## AMENDMENT NO. 3

**Project:** **Anderson County  
AgriLife Training Facility**  
603 N. Sycamore St.  
Palestine, Texas 75801

**ASI No:** No. 2

**SITE AND UTILITY PLAN**

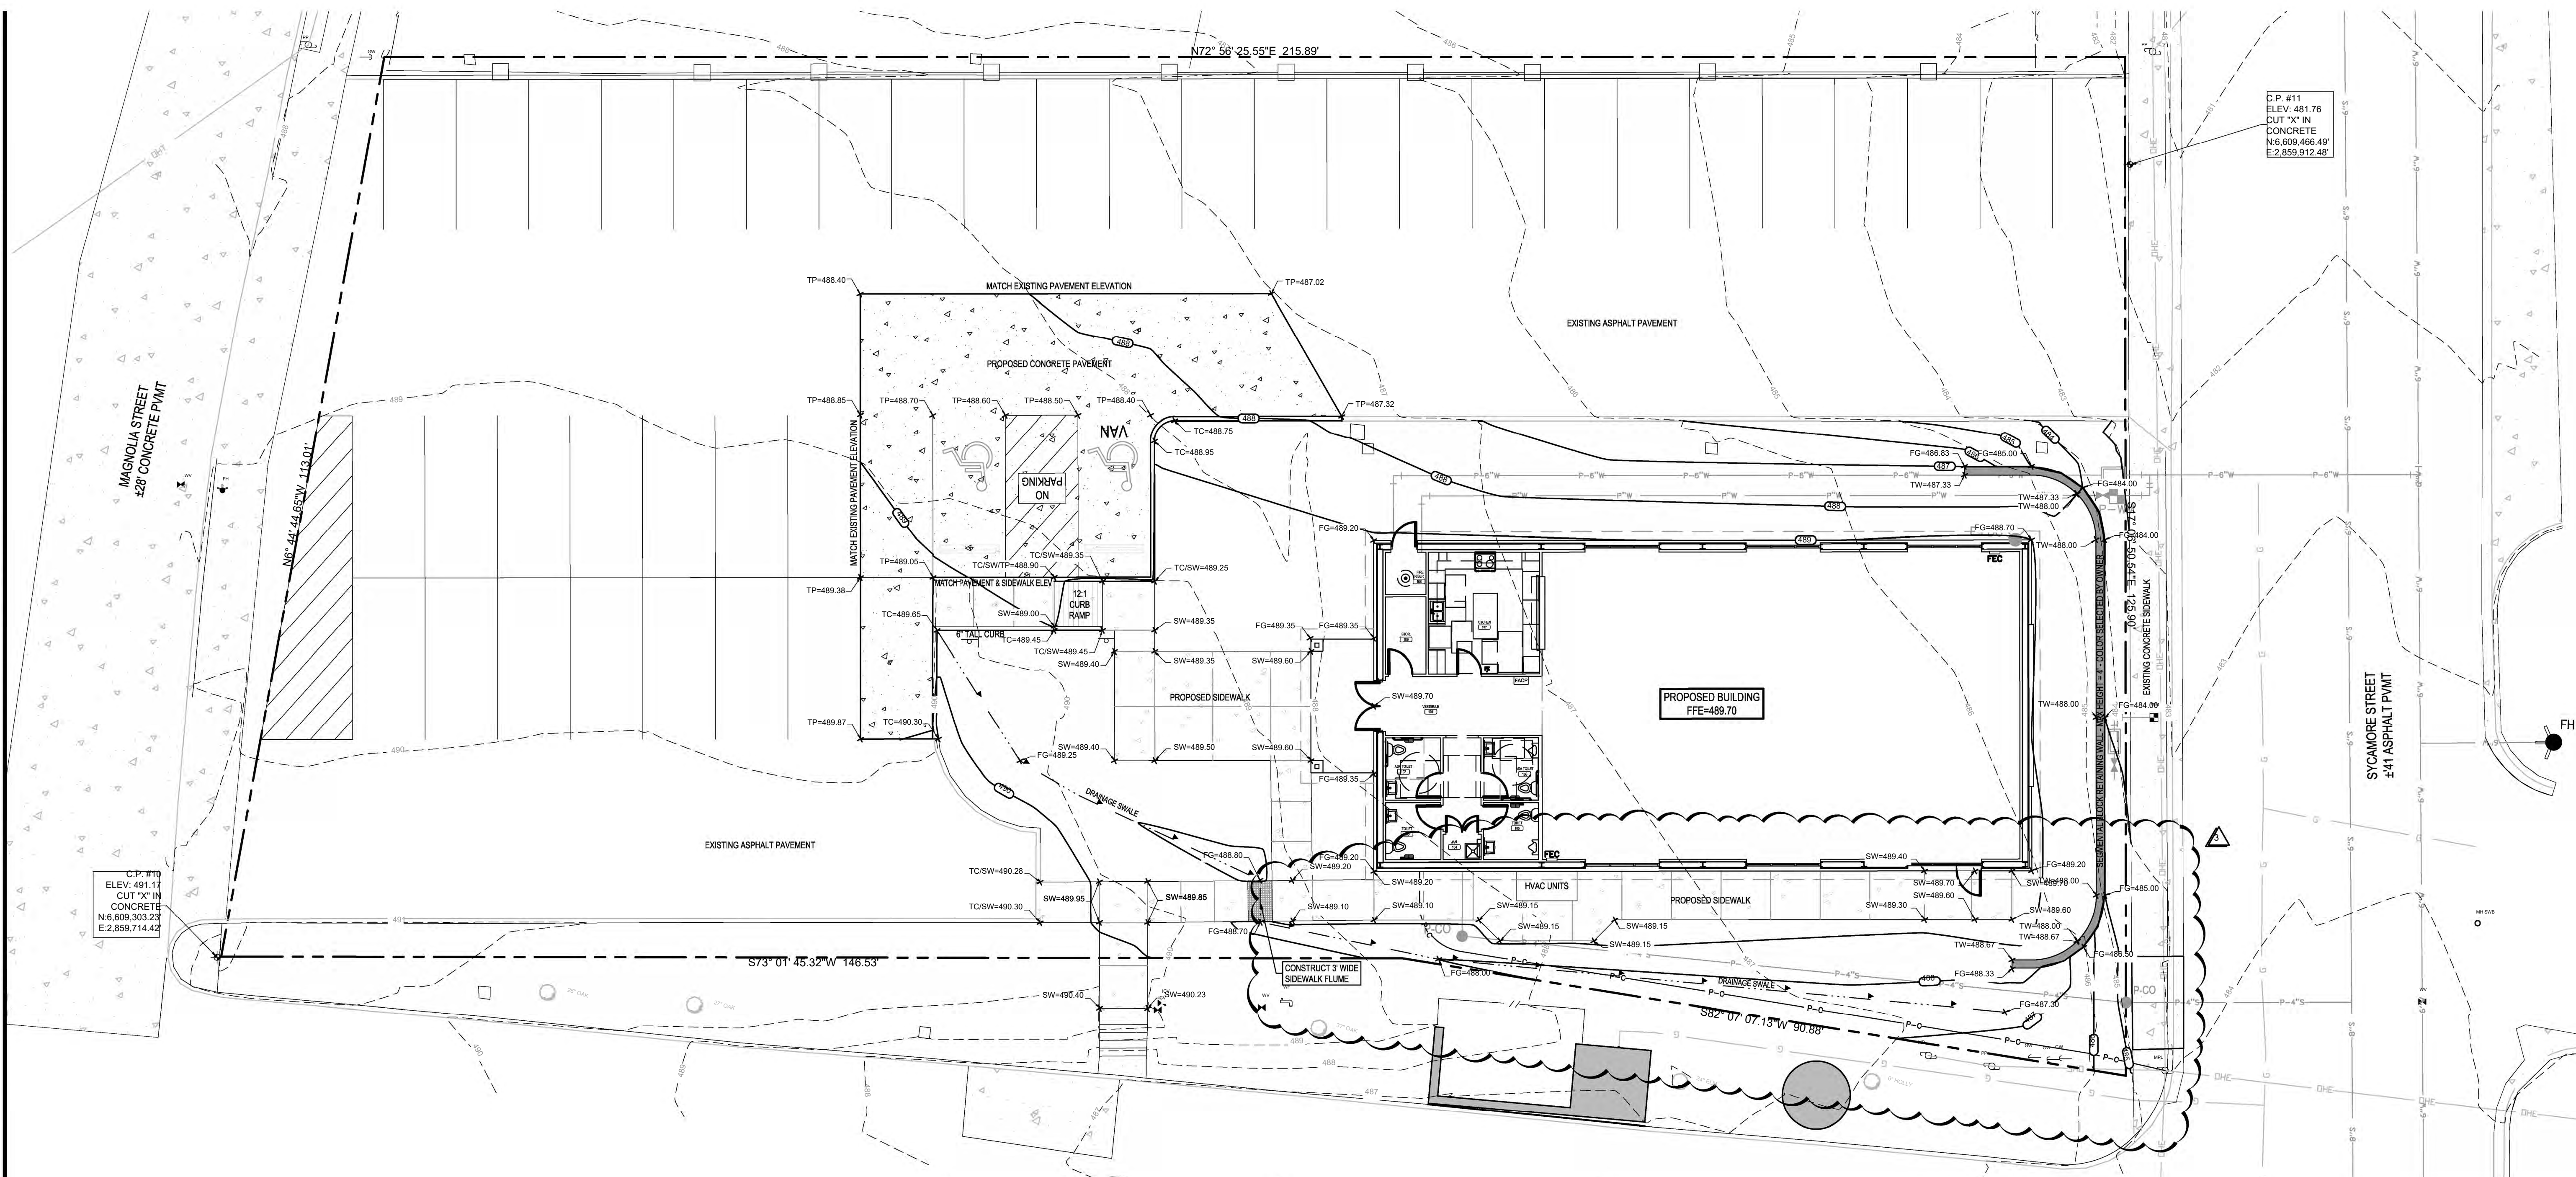
1. The sidewalk around the HVAC units on the south side of the building was widened to account for the equipment.
2. The 2" telecom conduit noted in item 1 for sheet E2.1 was added to the plan.
